UNITED STATES PATENT AND TRADEMARK OFFICE

| APPLICATION NO. | FILING DATE | FIRST NAMED INVENTOR | ATTORNEY DOCKET NO. | CONFIRMATION NO. |
|-----------------|-------------|----------------------|---------------------|------------------|
| 10/586,898 | 06/04/2007 | Volker Haeckh | 038724.57896US | 4772 |

| Office Action Summary | Application No. 10/586,898 | Applicant(s) HAECKH ET AL. | |

DETAILED ACTION

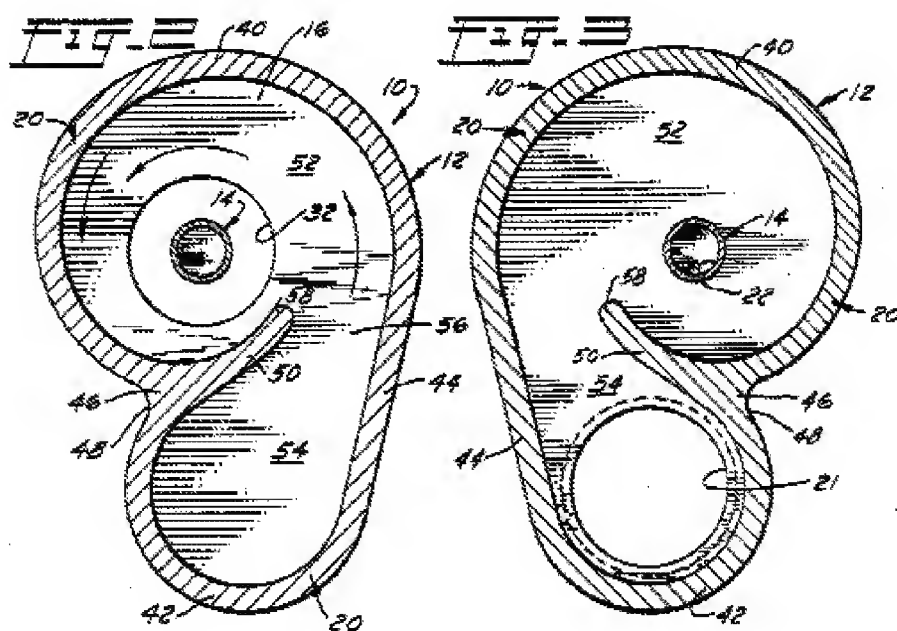
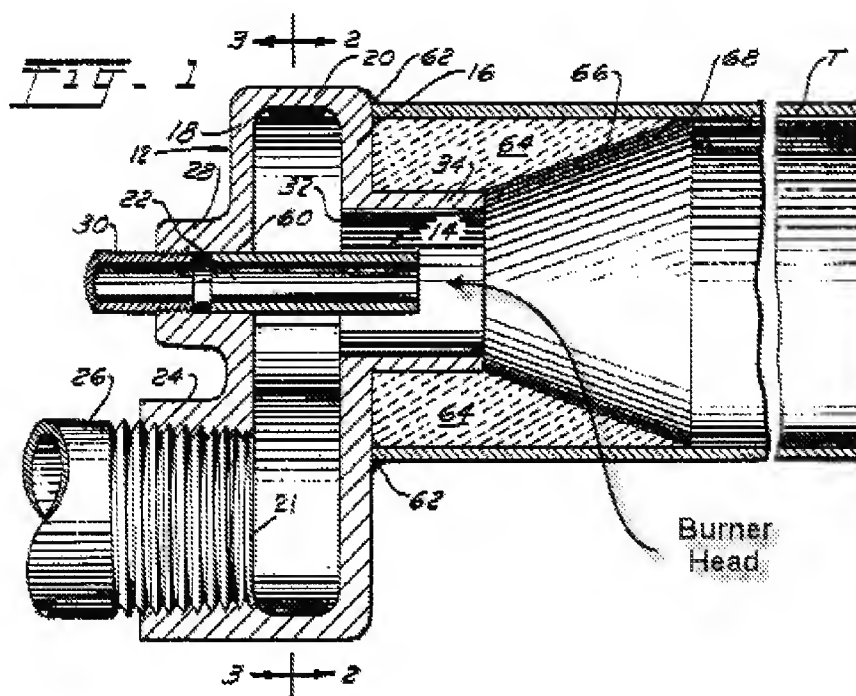
10. In re claim 18, with reference to figures 1-3 below, Keating discloses an externally mixing burner (10) having a burner head (see figure 1 below), at least one combustion gas tube (14) and at least one tube for an oxygen-containing gas (24), wherein the burner head has outlet openings out of the combustion gas tube and out of the tube for the oxygen-containing gas (see figure 1 below), wherein gas inlet lines (30, 26) are provided for a combustion gas and for the oxygen-containing gas, each being connected to a source for combustion gas and/or for oxygen-containing gas (inherent), respectively, and wherein at least one gas inlet line (26) opens eccentrically into a swirl

chamber (52) which is arranged between the gas inlet line and the combustion gas tube and/or between the gas inlet line and the tube for oxygen-containing gas (34).

11. In re claim 22, with reference to figures 1 and 2 above, Keating discloses wherein the swirl chamber (52) has a circular cross-section in a section perpendicular to a longitudinal axis of the combustion gas tube (14).

12. In re claim 23, reference to figures 1 and 2 above, Keating discloses wherein the gas inlet line (26) opens tangentially (56) into the swirl chamber (52).

15. In re claim 35, with reference to figures 1-3 above, Keating discloses a burner (10), comprising: a combustion gas tube (14); a first gas inlet line (30) coupled to the combustion gas tube; an oxygen-containing gas tube(34); a second gas inlet line (26) coupled to the oxygen-containing gas tube; and a swirl chamber (52), wherein the swirl chamber is disposed between either the first gas inlet line and the combustion gas tube or between the second gas inlet line and the oxygen-containing gas tube.

16. In re claim 37, with reference to figures 1-3 above, Keating discloses a method for operating a burner (10), comprising the steps of: controlling a flow of a combustion

gas (via gas supply line 30) to a combustion gas tube (14); controlling a flow of an oxygen-containing gas (via gas supply line 26) to an oxygen-containing gas tube (24); swirling the combustion gas or the oxygen-containing gas in a swirl chamber (52); and supplying the combustion gas and the oxygen-containing gas to the burner (inherent).

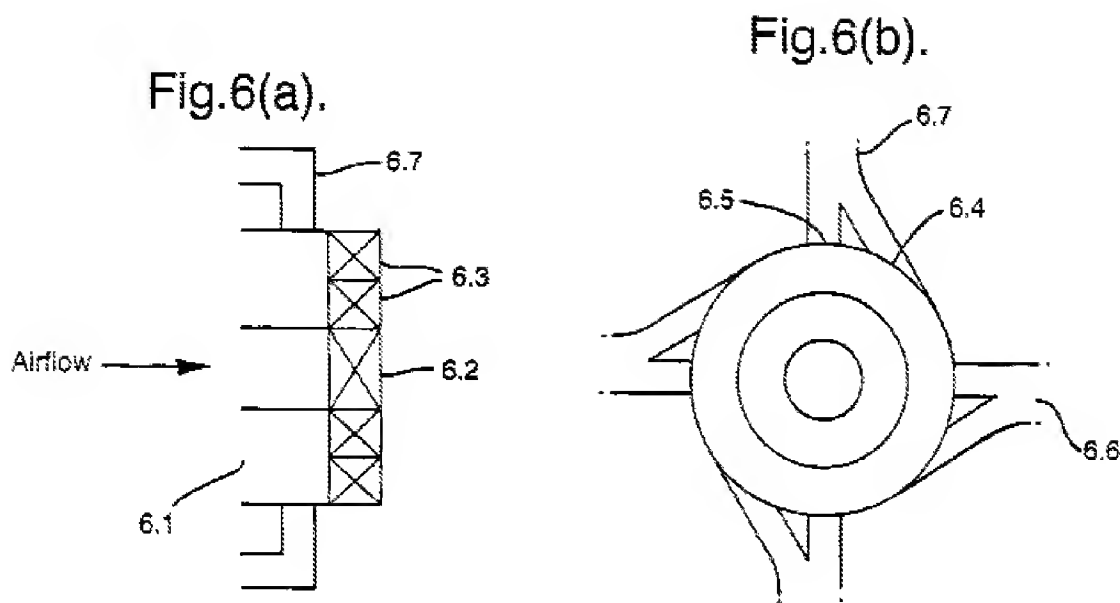
22. Nonetheless, with reference to figures 6(a) and 6(b) below, Brundish discloses a fuel injector including an air flow conduit (6.1), a combustion fuel flow conduit (not shown) and swirlers (6.2, 6.3) wherein at least one of the gas inlet lines (6.7) is divided into two lines (6.4, 6.5) upstream of a swirl chamber (6.3), wherein one of these lines (6.5) opens directly into the combustion gas tube and/or into the tube for oxygen-containing gas.

39. Nonetheless, with reference to figures 6(a) and 6(b) of Brundish above, Brundish discloses gas inlet lines that split into a first and a second portion that couple to the gas tube and have control means (see column 5, lines 16-22 and column 7, lines 24-35).

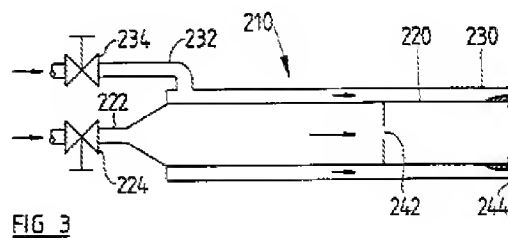
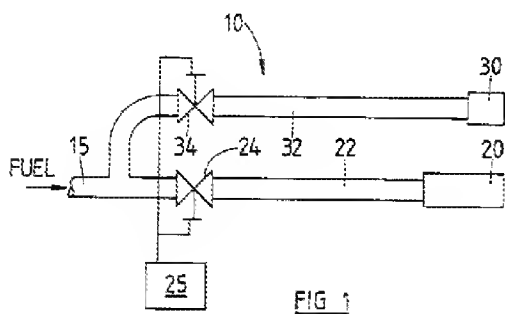
47. Nonetheless, with reference to figures 1 and 3 below, Luxton discloses a burner configuration including means to control the proportions of fuel flow wherein a quantity of combustion gas and oxygen-containing gas supplied to the burner per unit of time is controlled and/or regulated, wherein the combustion gas and the oxygen-containing gas are sent through valves (224, 234) wherein a degree of opening of the valves is controlled or regulated such that the burner produces a flame having a desired shape which is adjustable via a control and/or regulating unit (25). (See column 3, lines 45-50 and column 4, lines 30-52).
